Revision	Description	Date
5		
4		
3		
2		
1	ISSUED FOR ADDENDUM #2	20150410
0	Design Completion

Project title
PLEASANT CAMP PORT OF ENTRY TENDER A, SITE SERVICES & SITE SERVICES BUILDING

Drawing title
STEEL CANOPY GL 7-8 ROOF PLAN

Project no.	Sheet	Revision
R.071363.001	SKS-001	0

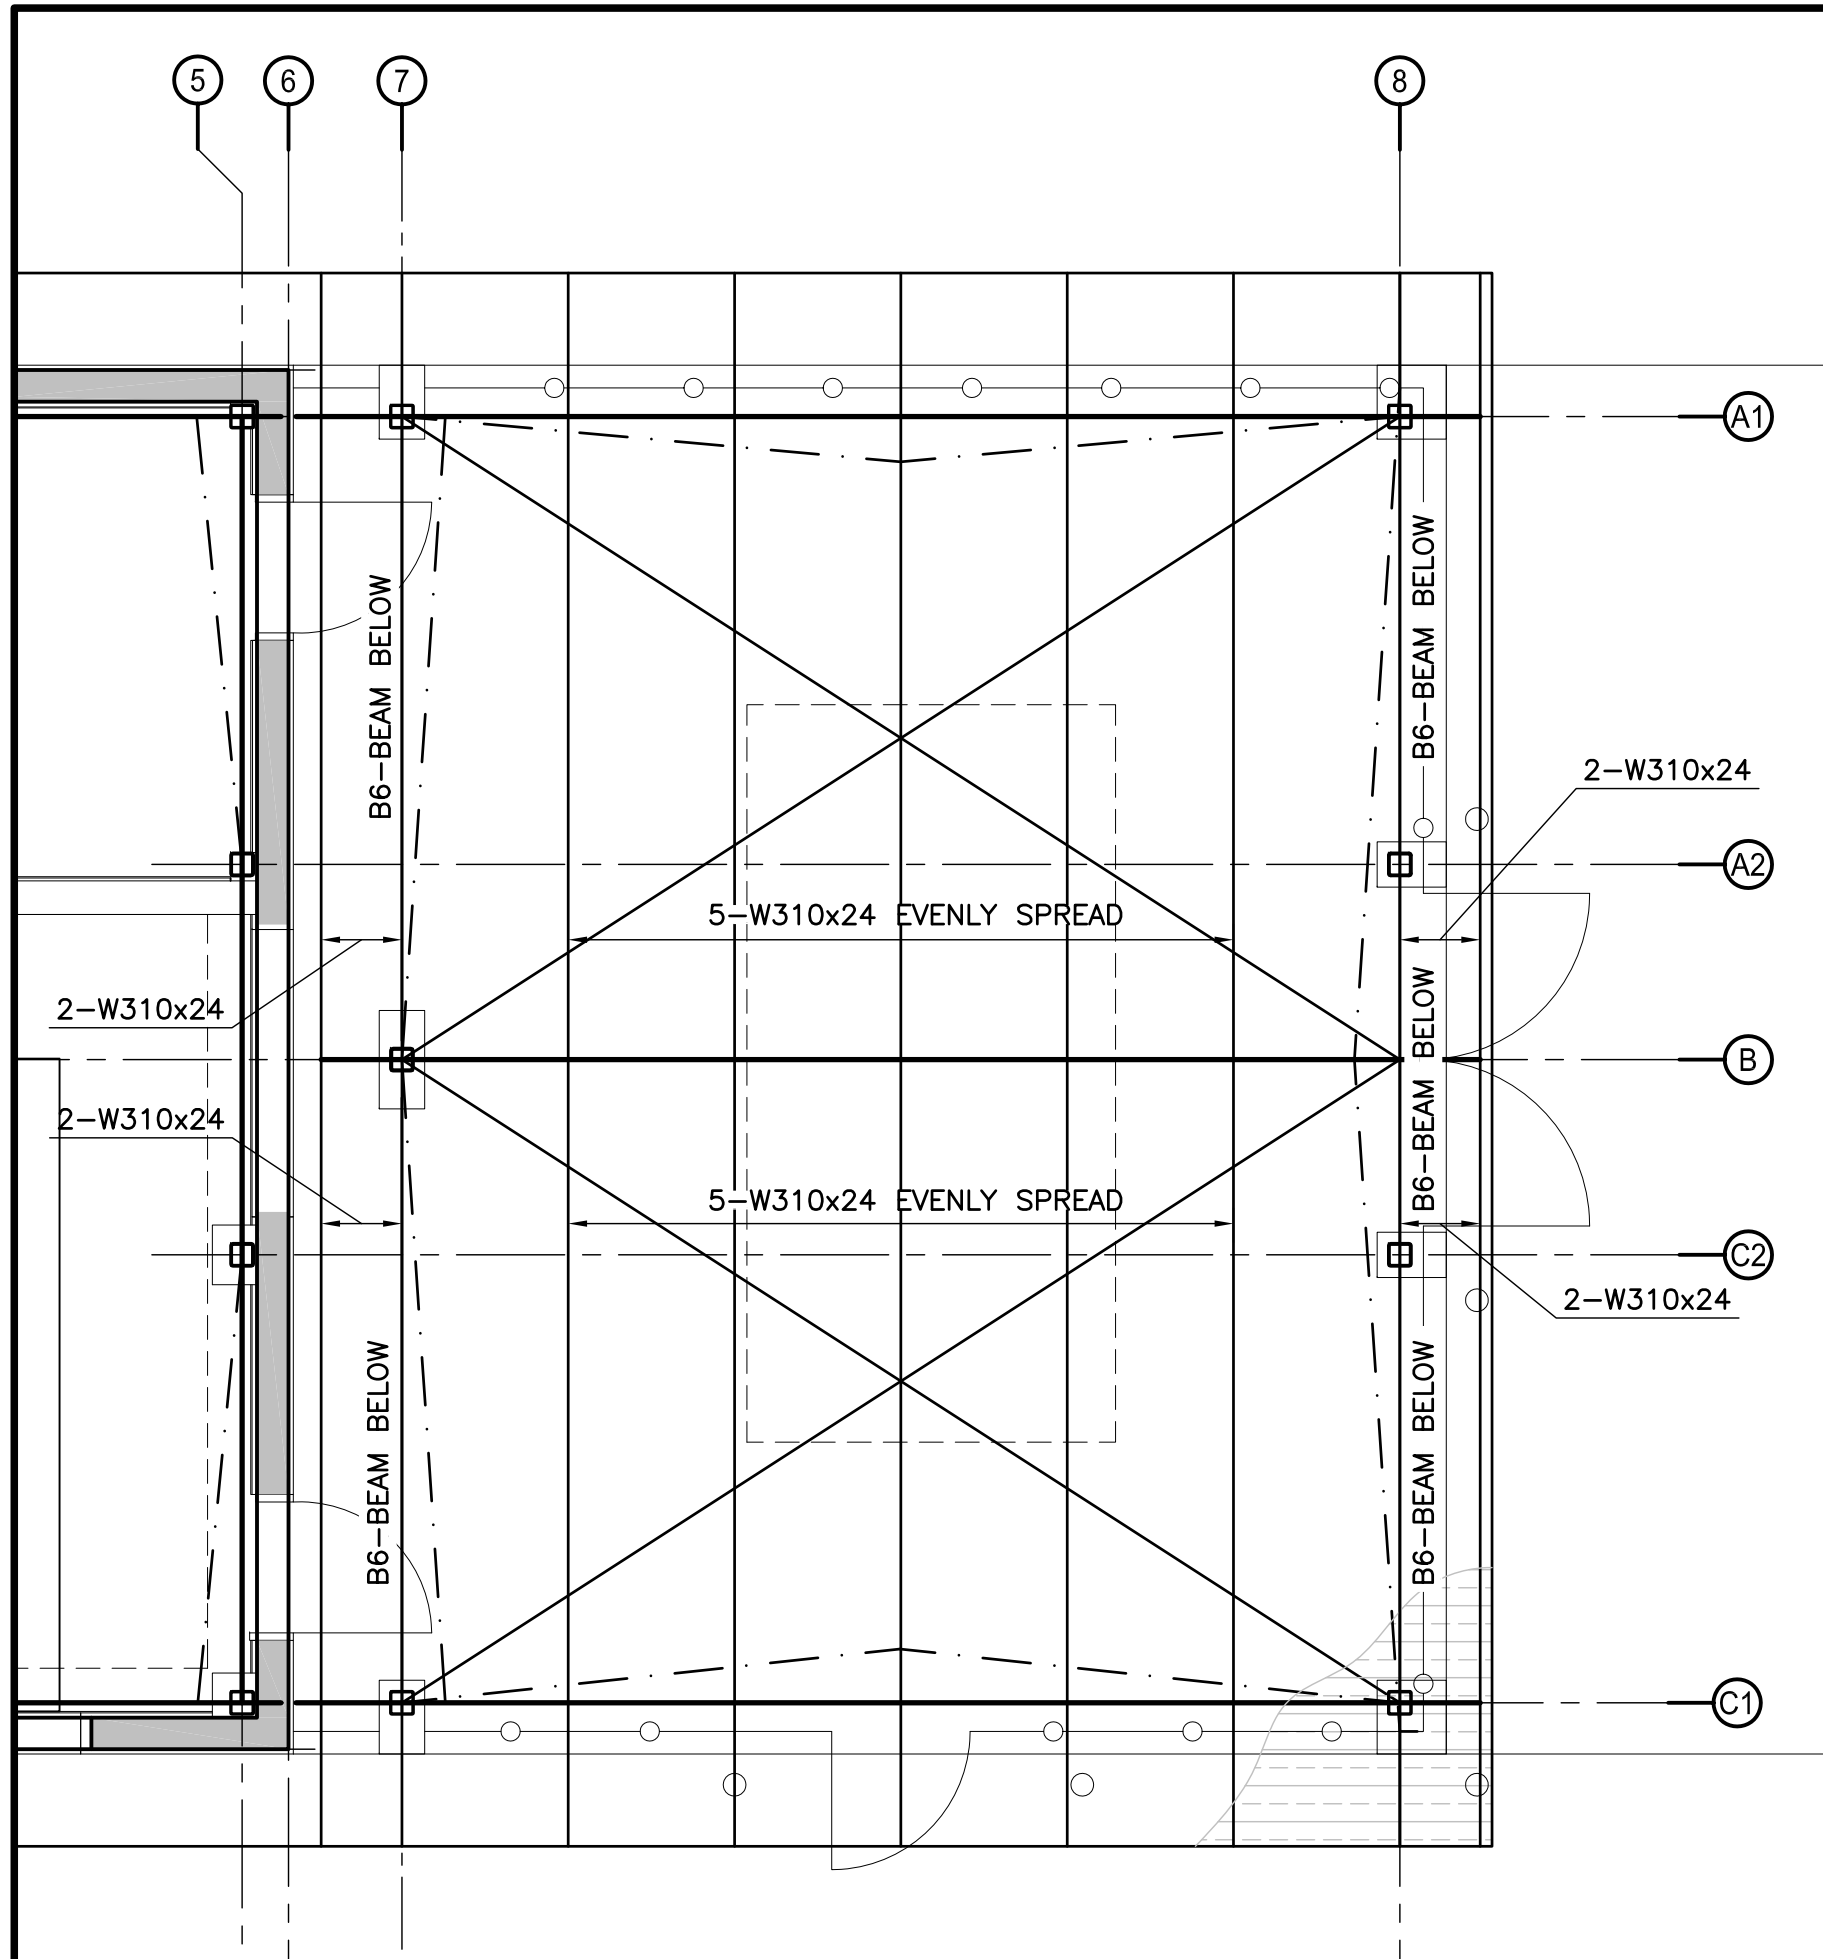
BEAM SCHEDULE	
LABEL	SIZE
B6	HSS 127x127x6.4

1. ONLY MODIFIED ITEMS SHOWN, THE ORIGINAL ITEMS SHOWN ON CONSTRUCTION DOCUMENTS STILL APPLY
2. SEE SECTION 2/S-301 FOR BEAM CONFIGURATION AT GL 7,8
